**In the matter of the Cambourne to Cambridge Transport and Works Act Order
application made by Cambridgeshire County Council (and Greater
Cambridgeshire Partnership)**

Proof of Evidence on behalf of Clare Hall in relation to heritage matters

**Objector Number (OBJ213)
Inquiry reference (TWA/24/APP/03)**

Figure 29 Extract of applicant's drawings (CD1-16.04 Sheet 17 or 17) showing the section of land between the rear wall of Clare Hall and Rifle Range Road inside the red line boundary

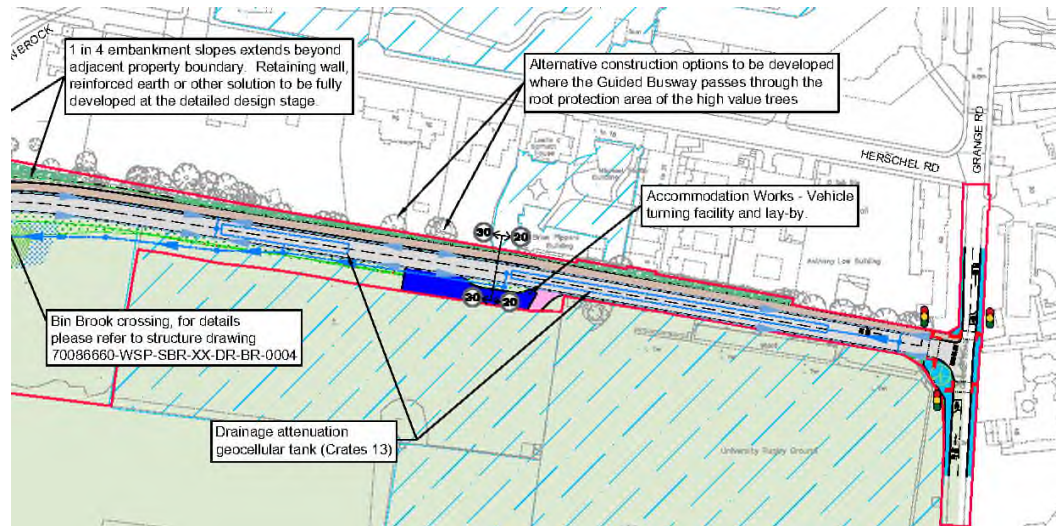
- 6.1.1. Figure 29 shows an extract of the proposed site layout (CD1-16.04 Sheet 17 or 17) drawing provided by the applicant which plots the red line site boundary of the Cambridge to Cambourne (C2C) proposed busway stepping in towards and running along the southern edge of Clare Hall with the red line extending across Rifle Range Road from the face of the main external southern walls of Clare Hall buildings to the fence enclosing the rugby pitch.

- 6.1.3. The C2C order limits, as shown in the section and plan above (Figure 29 and 30), indicates an Emergency Maintenance (E.M.) access track running parallel to Clare Hall, positioned between the busway and the buildings. The drawing extract (Figure 29) also indicates that the existing trees are to be removed, and the original water channel, rainwater spouts, and the three pathways and bridges, **will be** directly impacted by the works as the red line boundary of the C2C order limits includes these original features.

- 6.1.4. The same applicant's drawing (figure 29) also indicates new hedgerows between Clare Hall and the emergency and maintenance access track.
- 6.1.5. In response to the flaws in the section described above, the applicant has recently submitted a new **Illustrative** section. The illustrative drawing (see figure 31) below received from WSP on 16/07/2025, is intended to show the correct site boundary condition but is illustrative only and cannot therefore be relied upon or scaled. Without dimensions on this revised drawing (figure 30) it is difficult to assess the impact the proposed emergency and maintenance access track works will have on the existing original paths, bridges and water features.

Figure 30 Extract of applicant's drawing (CD1-166.05 Sheet 5 of 5) showing an incorrect sectional relationship of the Clare Hall building with the red line boundary.

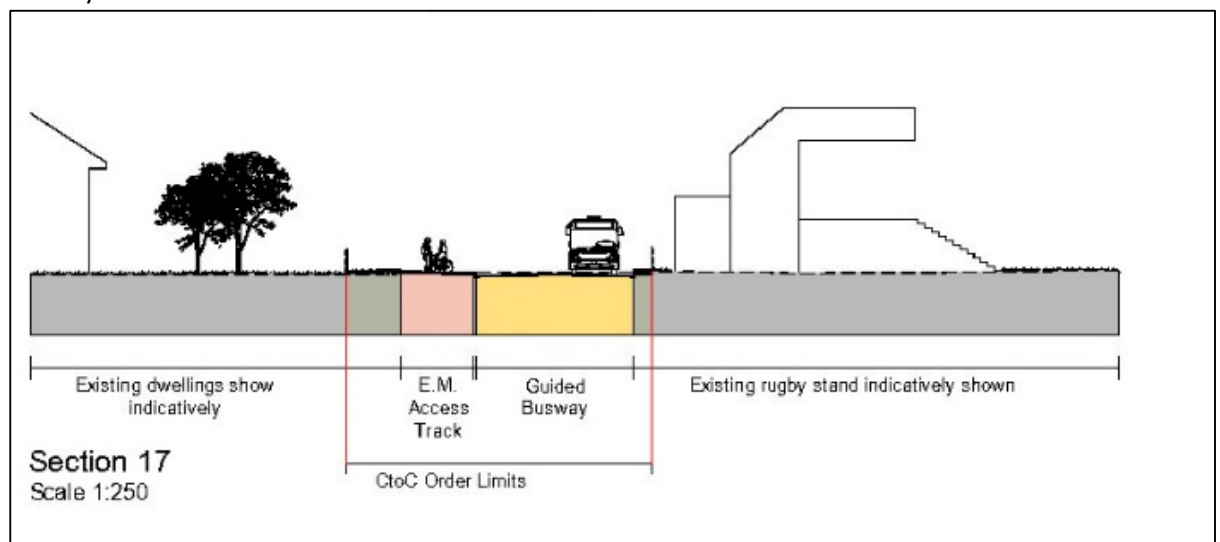
- 6.1.2. The section detail drawing (CD1-166.05 Sheet 5 of 5) (figure 30 below) submitted by the applicant **does not show the correct** relationship between the listed buildings of Clare Hall and the red line boundary as shown. The southern elevations of the Clare Hall buildings sit directly on this red line and not as shown below.

Figure 31 Extract of applicant's revised drawings showing the relationship of the Clare Hall buildings to the C2C scheme.

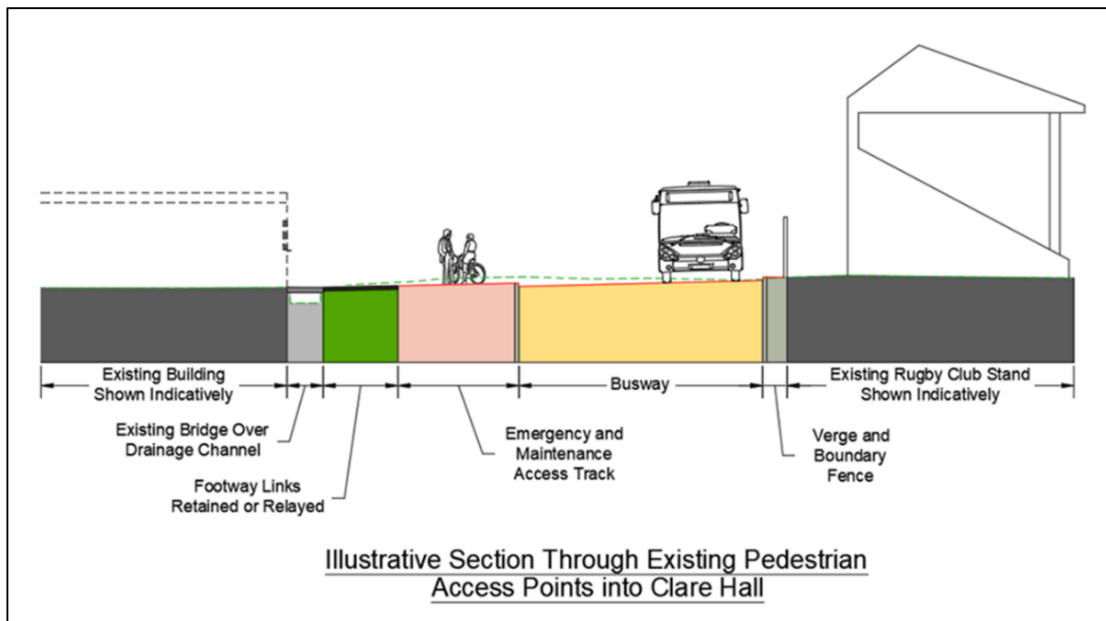
- 7.3.2. The revised sketched illustrative section (figure 31) provided by the applicant's engineers, WSP proposes planting and screening along the southern elevation of the listed buildings, directly in front of windows serving study rooms, and the main meeting room within Clare Hall. While it is assumed that this is intended to mitigate the adverse visual and acoustic impact of the adjacent busway, this intervention would have a detrimental effect on the interior quality and use of these spaces. The introduction of screen planting so close to the building would significantly reduce natural daylight levels, affecting the usability and comfort of rooms specifically designed for academic use. Furthermore, the screening would obstruct outward views. This erosion of visual permeability would diminish the experiential and

Figure 32 Revised sketch received from WSP applicant's consultant engineer

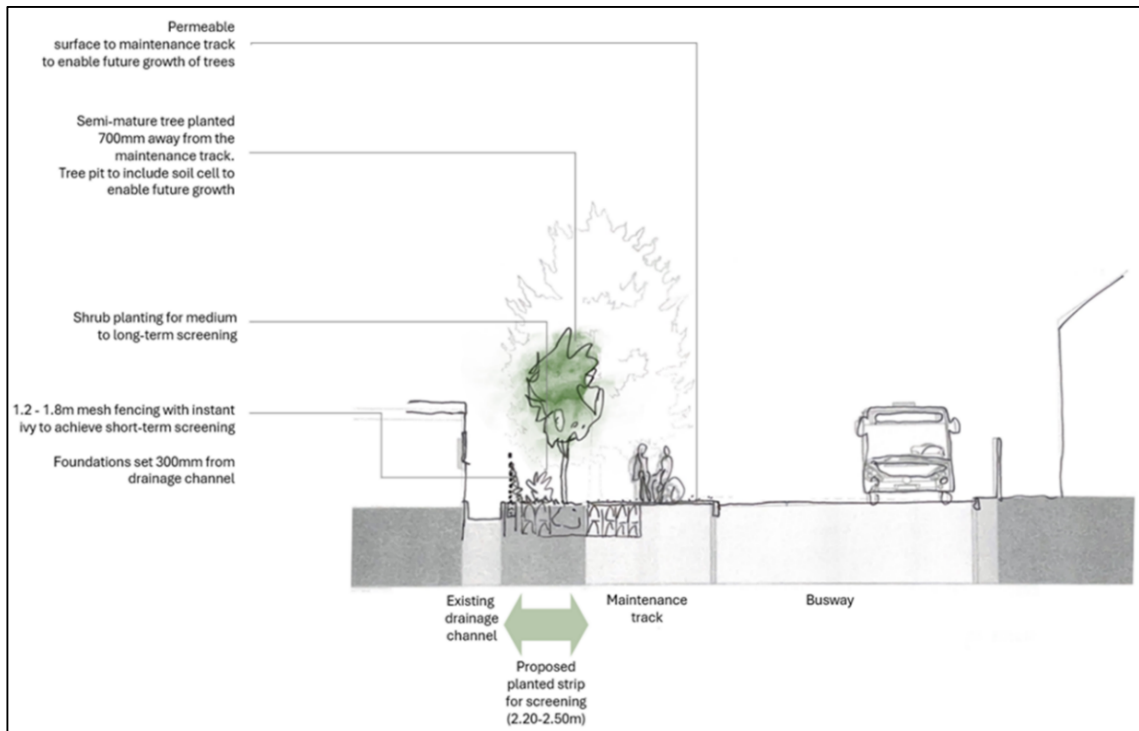
- 6.1.6. A further revised sketch sectional drawing received from the WSP on 16th July 2025 (see figure 32) below proposes short term screening directly outside the south windows of Clare Hall, Family and Scholars' Walk entrance openings and proposes a medium to long-term planted strip incorporating a semi-matured tree planted 700mm away from the busway. Any new trees alongside this maintenance track would need to take account of future access needs into Clare Hall.

Figure 34 Section showing relationship of study/meeting room with the proposed new C2C busway

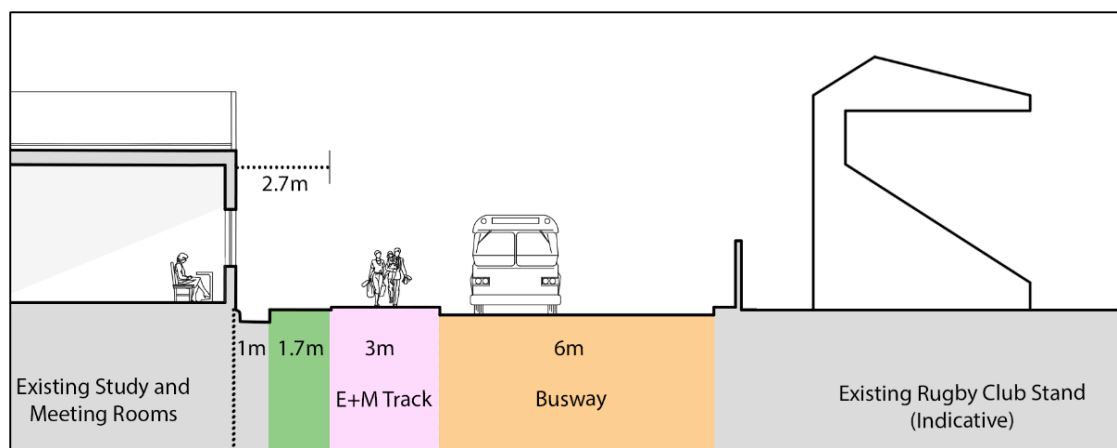
- 6.1.7. The drawing below (figure 33) prepared by Avanti Architects on behalf of Clare Hall, illustrates the existing site condition drawn from an accurate dimensional site survey recently commissioned by Clare Hall. The overall width of the land between the southern face of the Clare Hall buildings and Rifle Range Road is 5.2m. This includes the width of the drainage channel and the grassed landscaped edge. Based on the revised information (Figure 32) provided by the applicant, the full extent of the C2C busway would appear to require the grassed landscape strip to be reduced in width by 1.7m to accommodate the busway and maintenance track. Therefore, the landscaped edge would reduce from 5.2m wide to 3.5m and require each of 3 no. existing paths to be reduced in length by a 1/3 rd of their current length. (Refer Figures 33 and 34)

Figure 36 View of the passing bus from the study rooms prepared by Avanti Architects on behalf of Clare Hall from the information provided by the applicant.

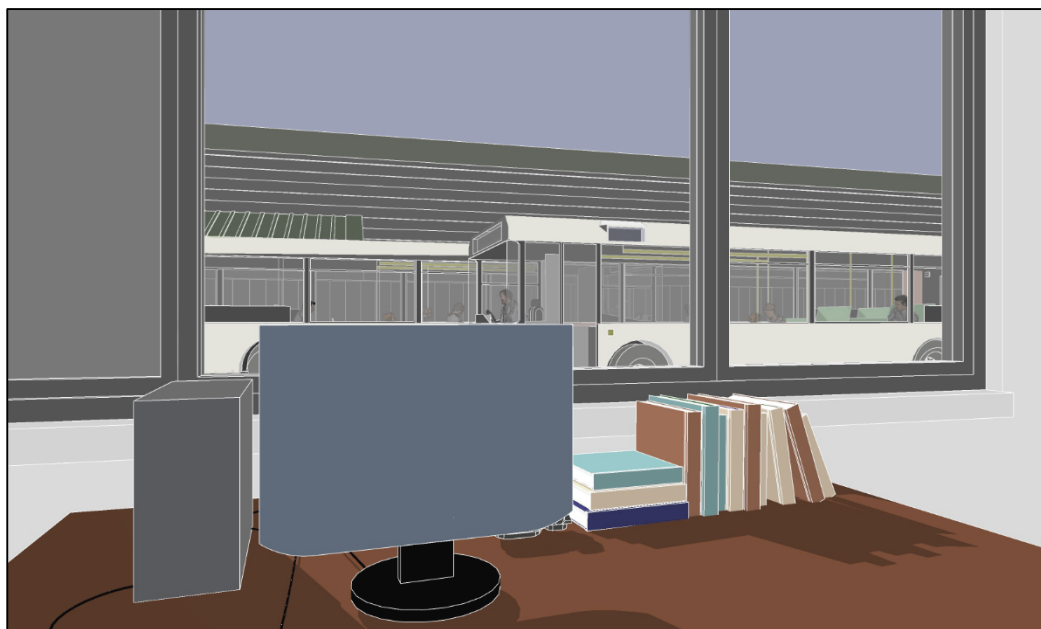
- 7.4.4. The busway will also have a significant impact on the courtyard house and the maisonettes to the south resulting from overlooking and noise from the passing buses. (see figure 36)

- 7.4.6. Any proposed planting/hedgerow would seriously reduce daylight within these rooms and block views out.
- 7.4.7. The close proximity of the proposed busway would also result in a significant loss of privacy and amenity for the affected rooms. These spaces currently enjoy a quiet and secluded outlook over the Rifle Range Road and the rugby field. Introducing a frequent bus route immediately adjacent to them would subject these spaces to regular visual intrusion. Although the ground floor windows have reflected film applied, the proximity of the bus to these rooms will result in a perceived intrusion on the users of these rooms. Previously private and inward-facing academic and residential spaces would be exposed to passing traffic, disrupting their intended function as quiet environments for study.
